MWO 186-1

MODIFICATION WORK ORDER

MODEL 131

SELCAL SYSTEM

Figure 1

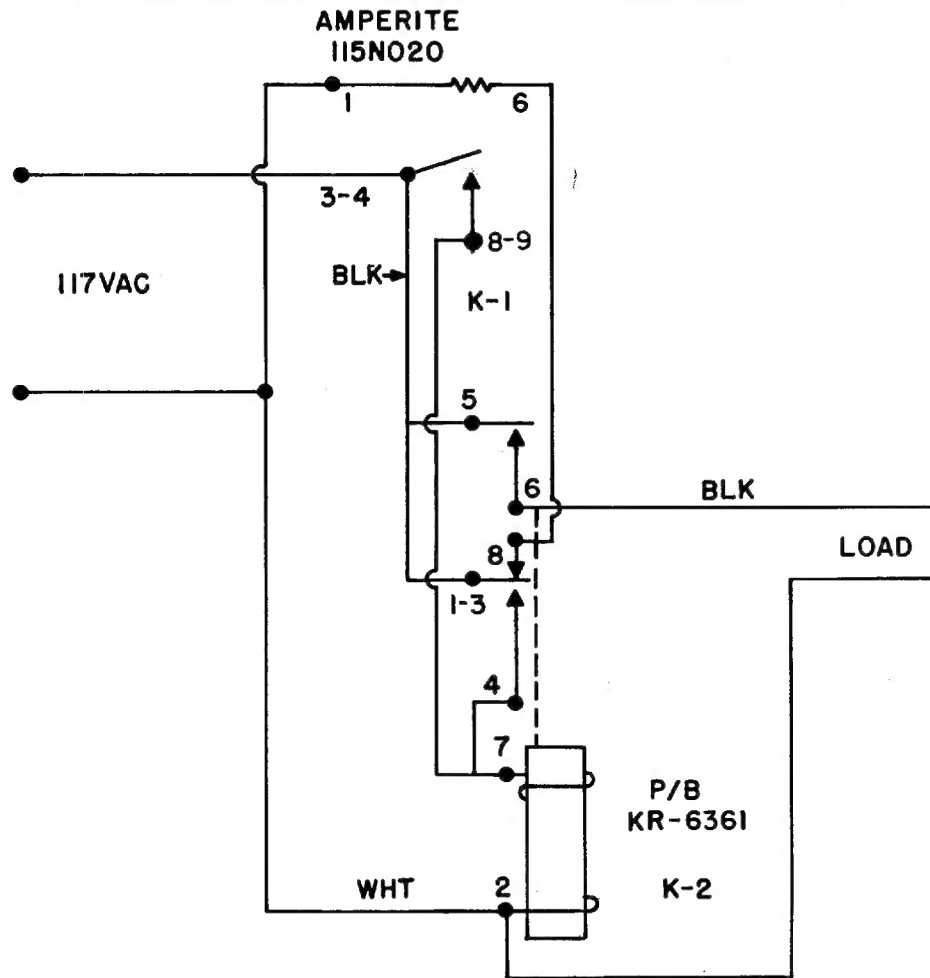
To prevent false triggering with AC power changeovers.

4.2 Remove the black AC wire from TB-2, Terminal 2. Cut off the lug and strip off 1/2" of insulation.

4.3 Solder this wire to pin 5 of the P/B KR-63⁶₁ octal relay socket (Pin 8 of KRP11). (See Figure 1).

4.4 Connect the black wire from pin 6 of the octal relay socket to TB-2, Terminal 2. (See Figure 1).

Figure 2

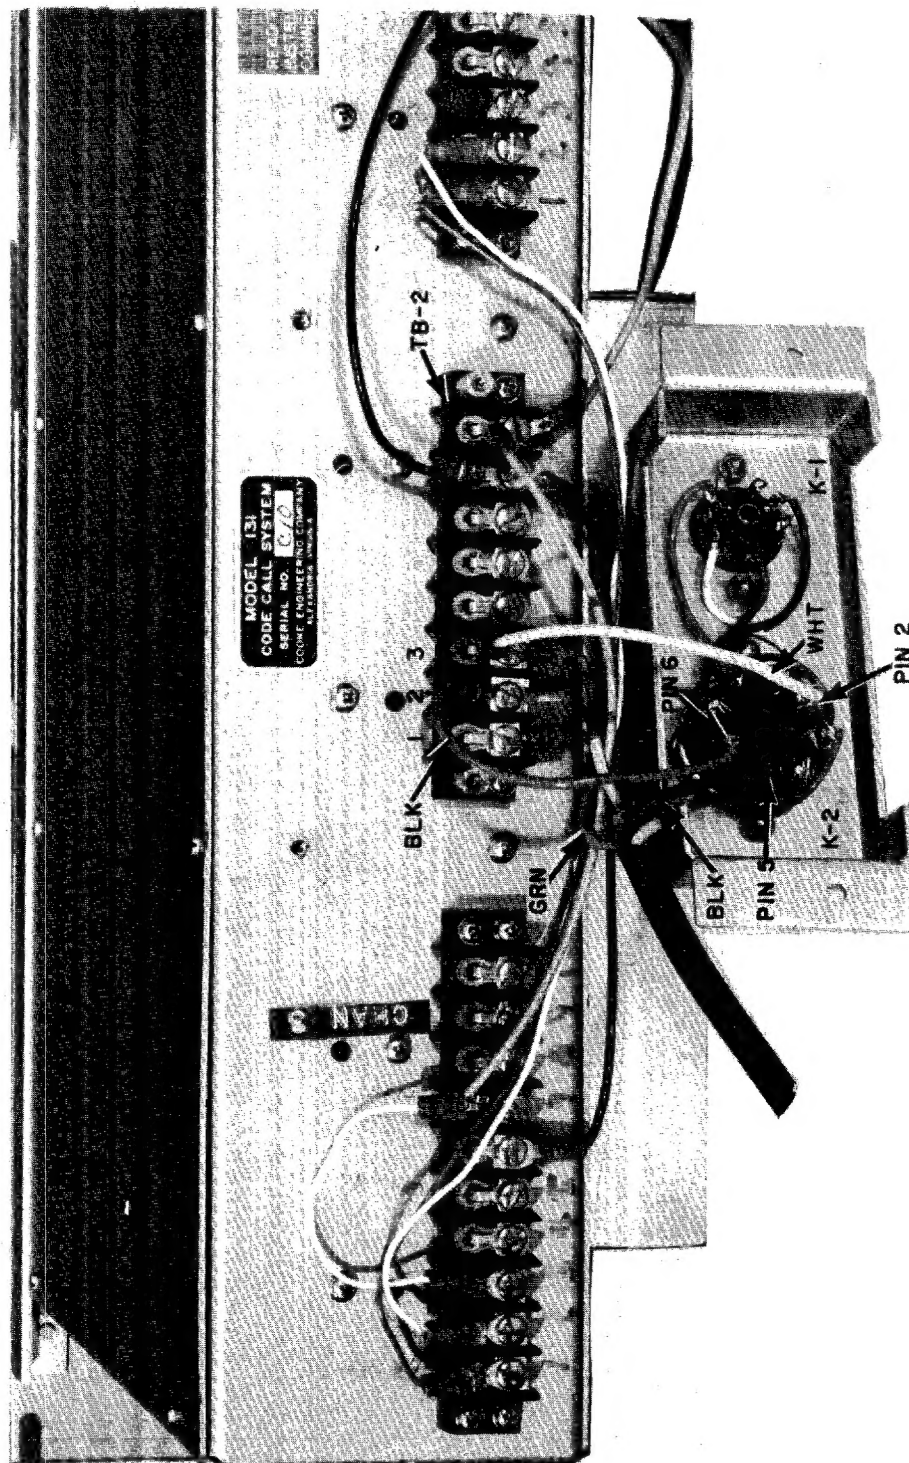
4.6 Attach the relay socket plate to the back of unit above TB-2.
Utilize the two screws/holes already present (See Figure 2).
